ITEM #6.4:	COMMITTEE OF ADJUSTMENT REPORT MINOR VARIANCE APPLICATION A121/22 39 Hillside Ave Concord
-------------------	--

COMMITTEE OF ADJUSTMENT REPORT
MINOR VARIANCE APPLICATION
A121/22
39 Hillside Ave Concord

ITEM NUMBER: 6.4	CITY WARD #: 4
APPLICANT:	Li Zhu
AGENT:	Serouj Kaloustian
PROPERTY:	39 Hillside Avenue, Concord
ZONING DESIGNATION:	See below.
VAUGHAN OFFICIAL PLAN (2010) DESIGNATION:	Vaughan Official Plan 2010 ('VOP2010'): "Low-Rise Residential"
RELATED DEVELOPMENT APPLICATIONS:	None
PURPOSE OF APPLICATION:	Relief from the Zoning By-law is being requested to permit the construction of a proposed single family dwelling, retaining wall and increased driveway width.

DRAWING NAME
DEMOLITION
SITEPLAN

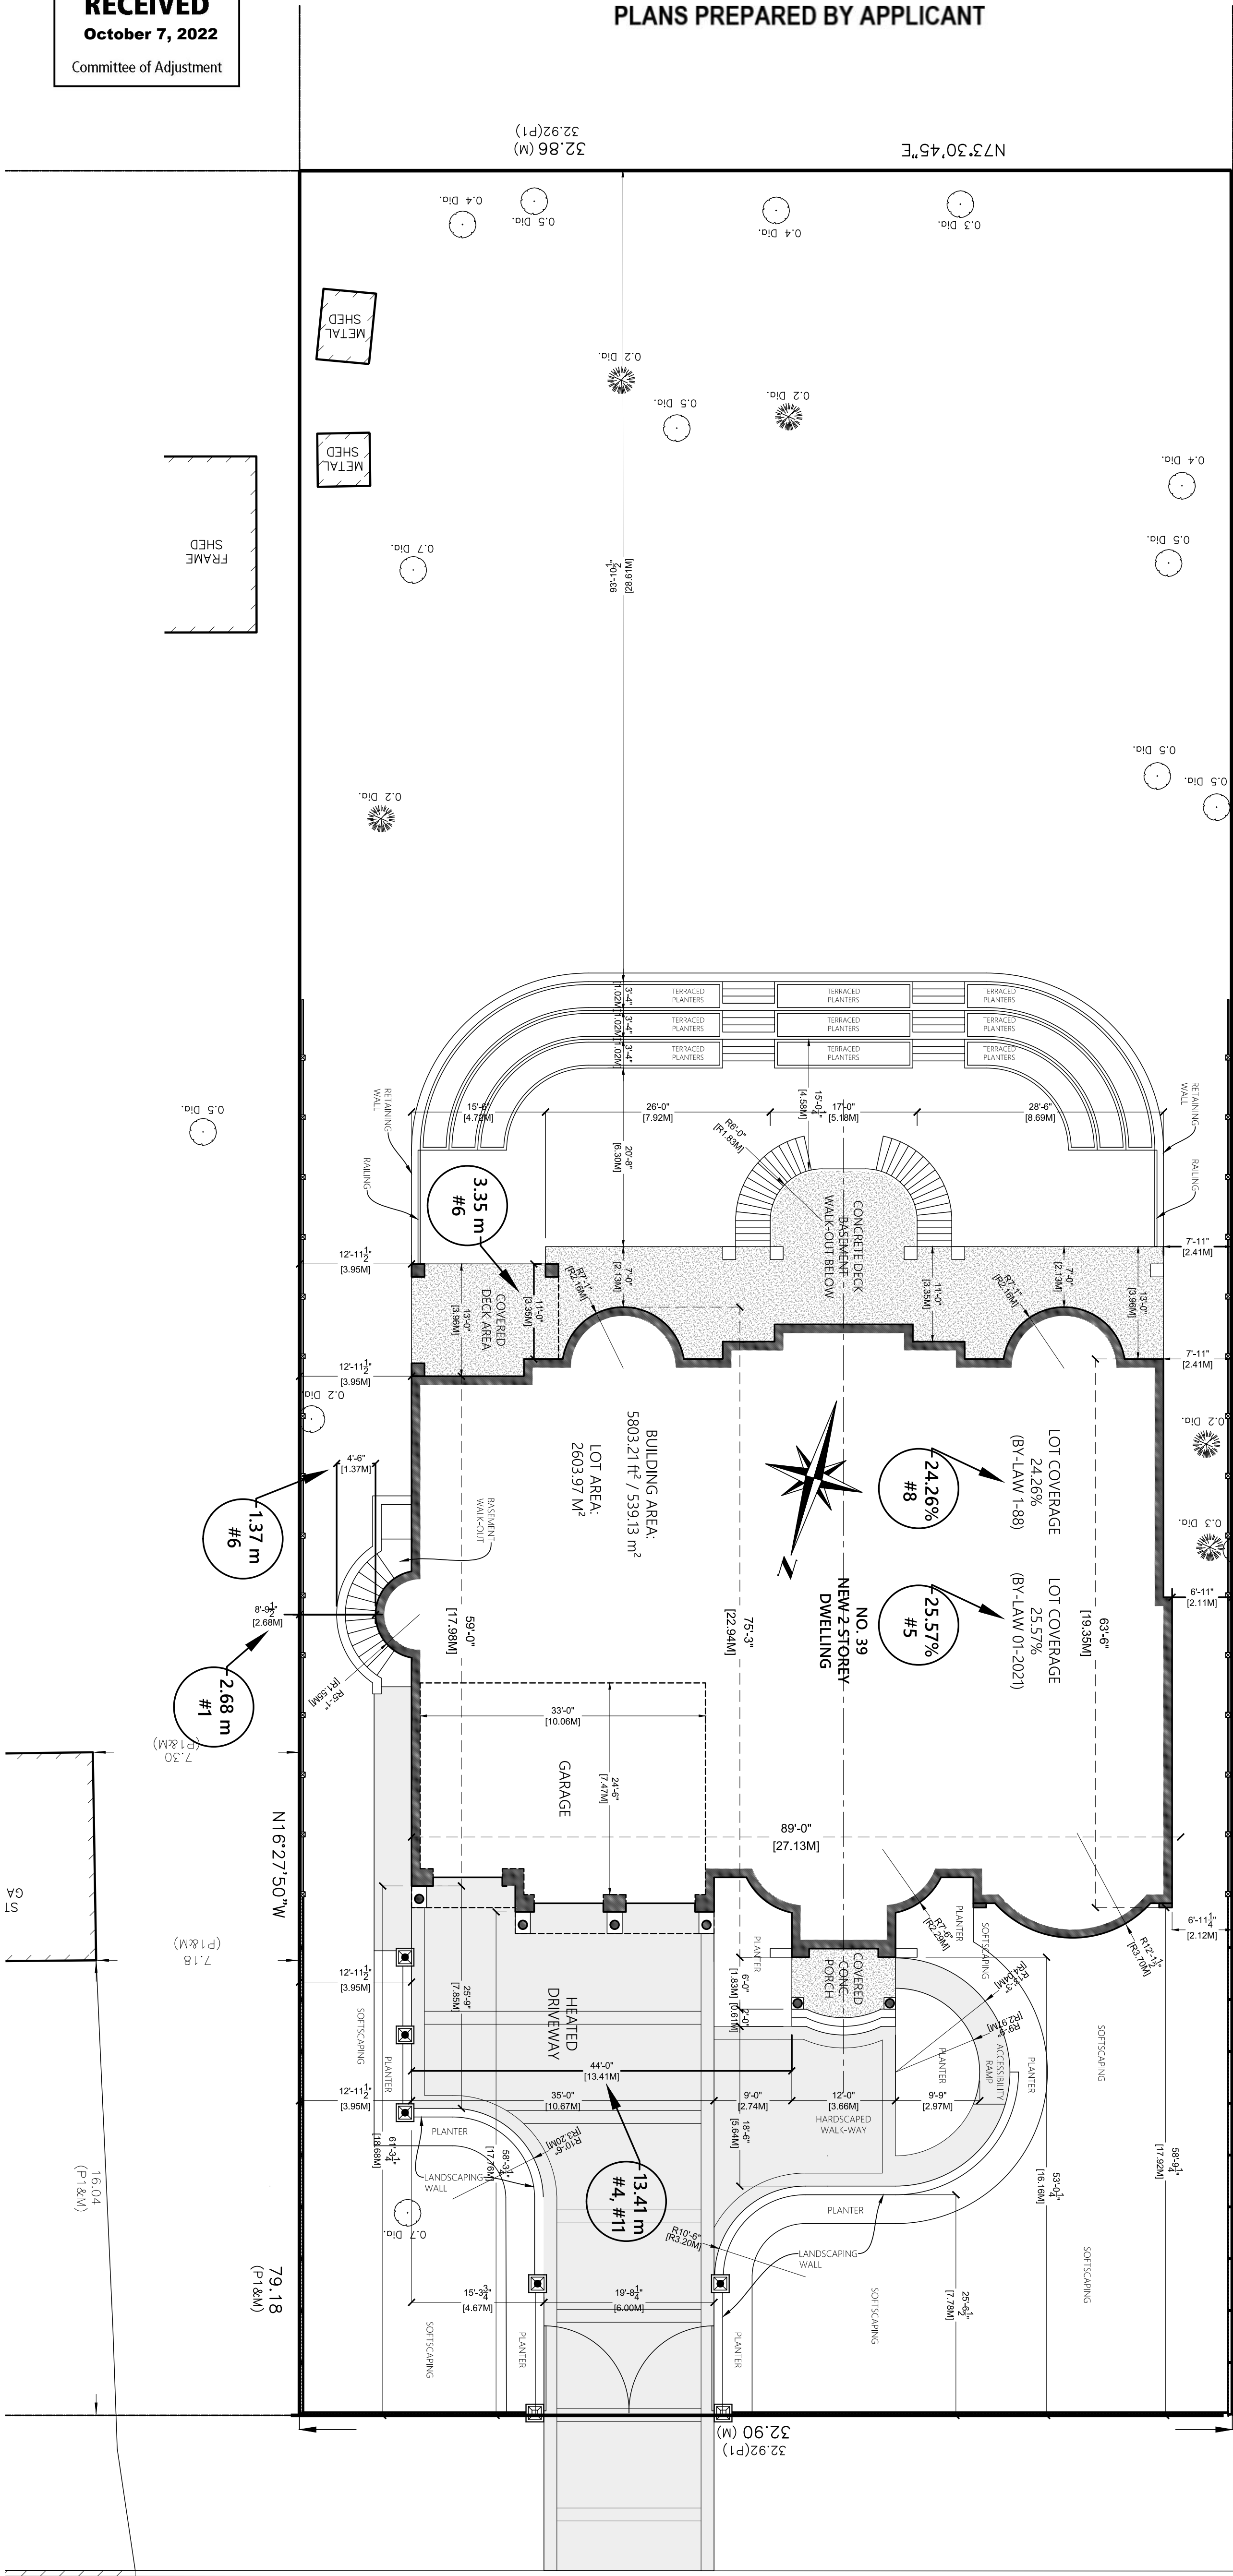
2. The drawings are not clear. They do not show the actual conditions and existing structures.
 - a. (Variance #1) Why is the existing house not shown on the demolition drawing so one can see the differences and variances? Furthermore, the existing fences are not clearly shown around 39 Hillside. A portion of the chain link fencing on the west property line was installed by one of the previous owners prior to 1979 and when we built, we continued the fence to our front building line. Subsequently the previous owners had some concern with the lighting along our easterly sidewalk and so we installed a wood privacy fence about 180mm west of our easterly property line and chain link fence. None of these are depicted on the site plan. Where are they measuring their setbacks from? We must ensure that these fences and any vegetation and trees are not affected by the 8 ft. plus excavation which is only. The basement walls are only 5 feet away from the property line. Assuming a 2ft. area for working the excavation will be less then 3 ft. from the property line.
